# DeKalb County Government

**File #:** 2019-4715  
**File Status:** Preliminary Item

**PETITION NO: N8. SLUP-20-1243621 (2019-4715)**

**Case No.:** SLUP-20-1243621 **Agenda #:** N. 8

SITE PLAN

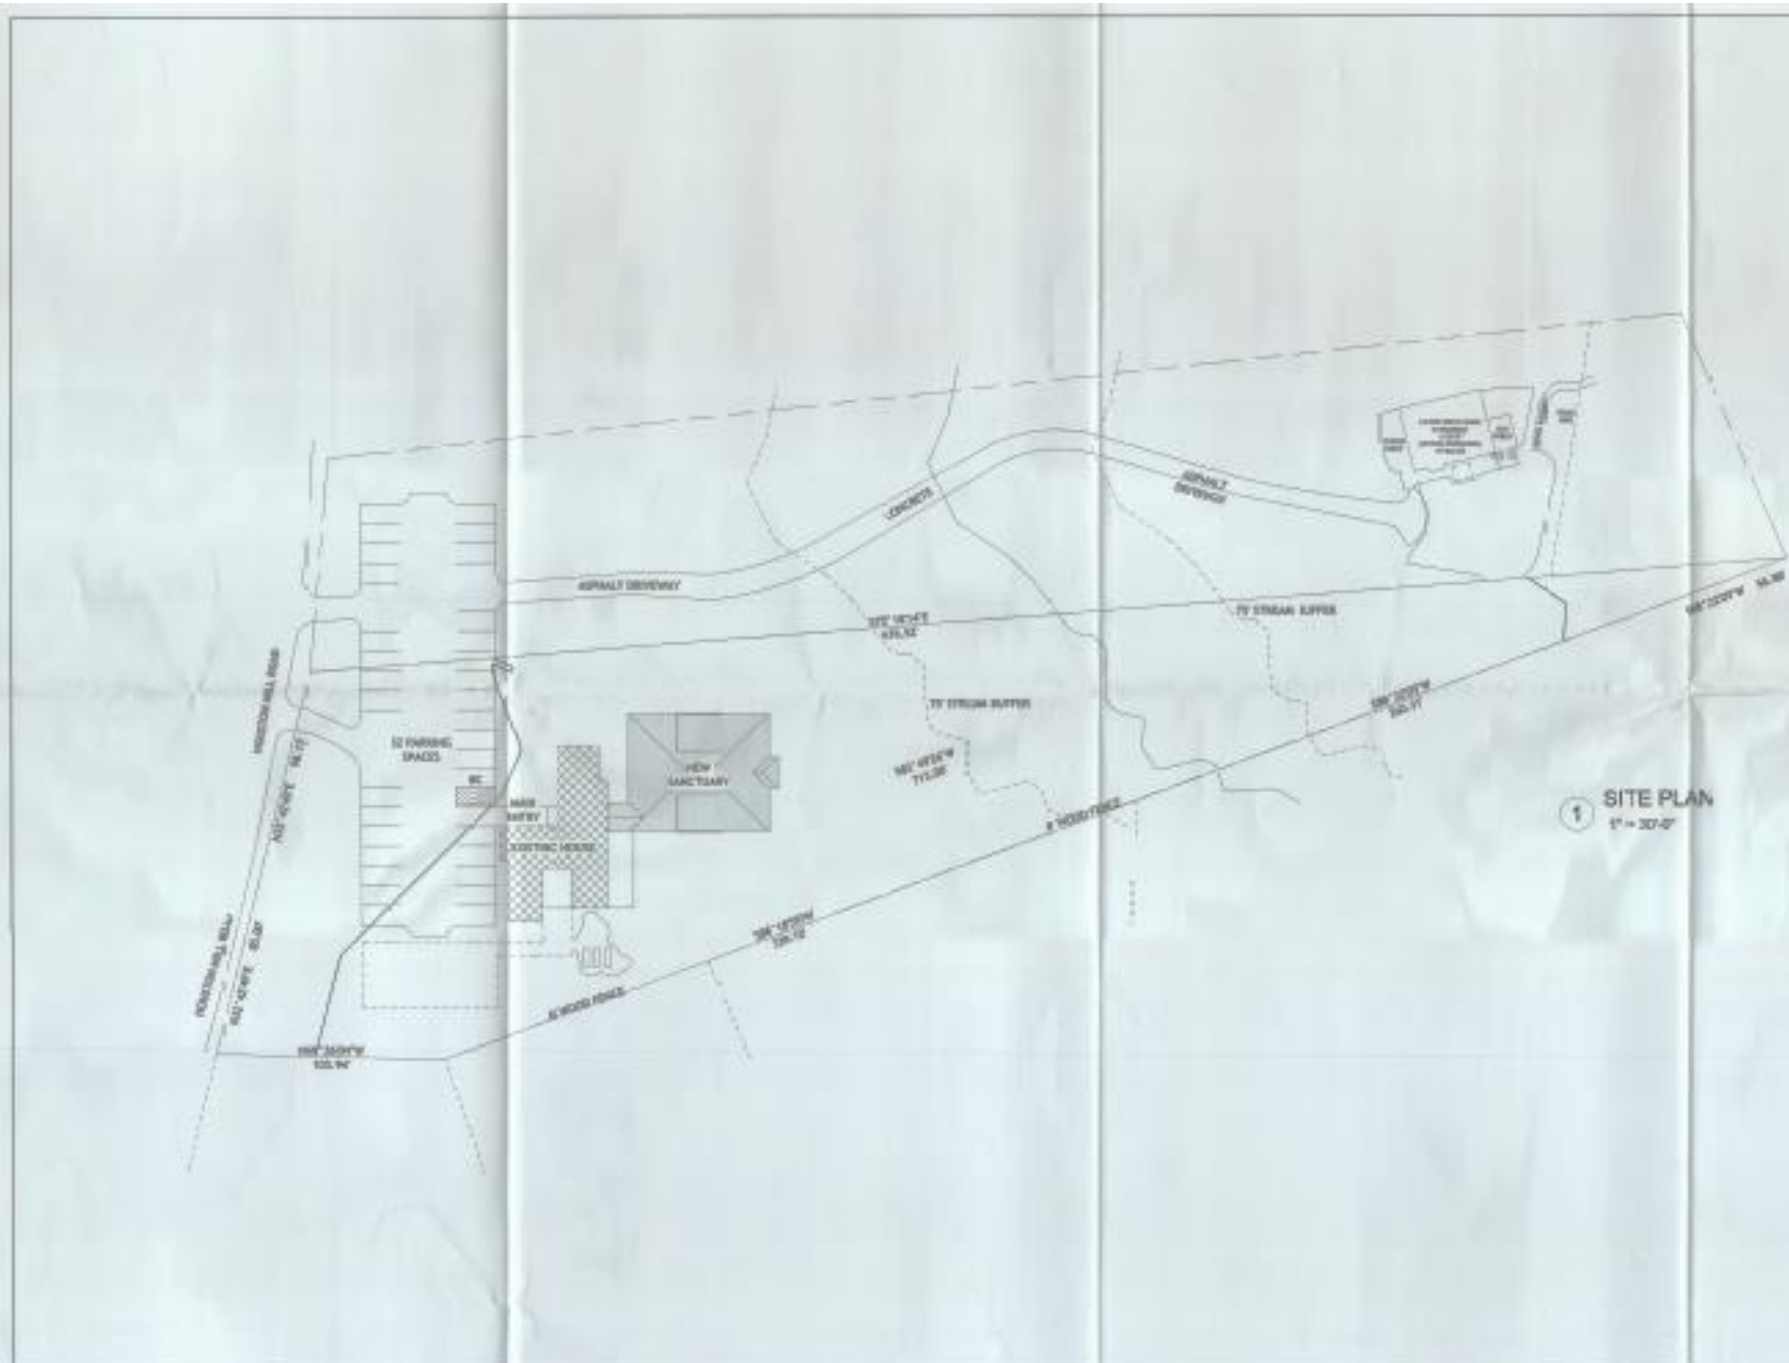
Based on the submitted site plan, the proposed place of worship does not meet this standard. The proposed place of worship is approximately 30.08 feet from the southern property that is zoned R-85 (Residential Medium Lot) District. The applicant is scheduled to go before the Zoning Board of Appeals on January 8, 2020 to request a variance from this standard.

Based on the submitted site plan, the proposed place of worship does meet this requirement.

Based on the submitted site plan, if this SLUP is granted, the proposed place of worship will meet this standard.
